CHANGE REQUEST NO. ILC-CR-000N	EDMS No: D0000000xxxxxxx	Created: 16-09-2014
		Last modified: 24-09-2014

DETECTOR HALL WITH VERTICAL SHAFT ACCESS

Change the underground experimental hall to a design that has a large vertical shaft and allows for the “CMS style” assembly of the detectors.

Drawing of the detector hall in the new proposed design with vertical shaft access (Y. Nishimoto, J-POWER).

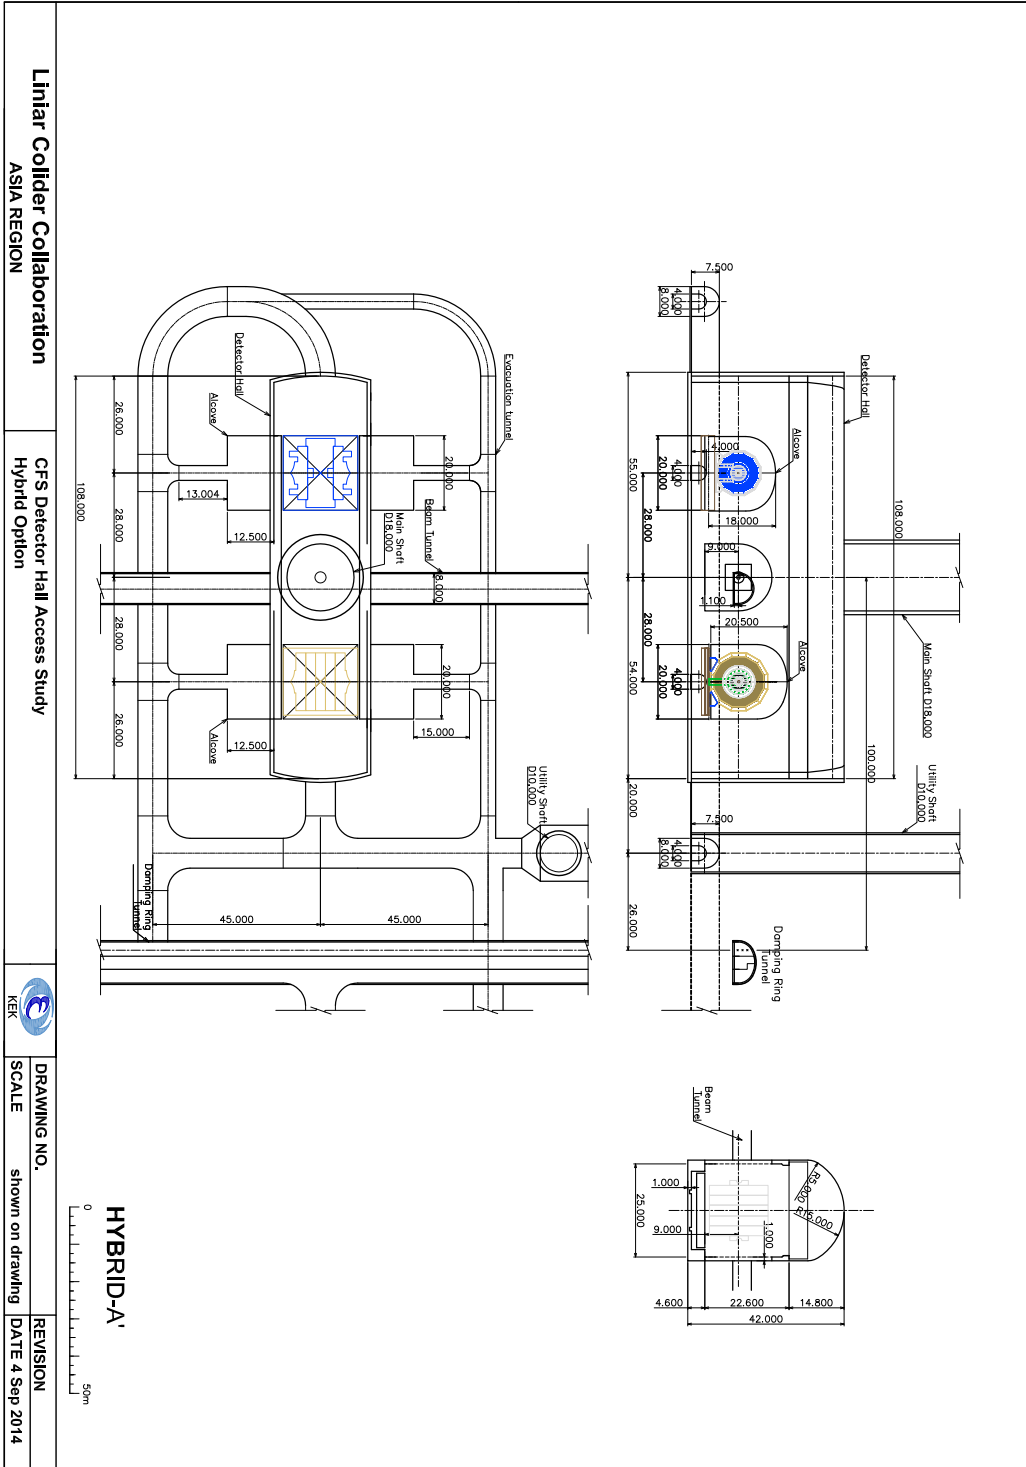
Studies have been performed to find an IR solution with vertical shaft access in the Kitakami region. The proposed design of the underground area is shown in Attachment 1.0. This design has one vertical 18m shaft directly over the interaction point that is used by both detectors for the assembly. In addition, services for the detectors (e.g. cryogenics) can be routed through the central shaft. Additional access to the underground area is provided by a service shaft of 10m diameter and by a horizontal tunnel with a width of 8m that mainly serves as access path to the damping rings. This current proposal has been discussed with all stakeholders in the IR region and finds approval.
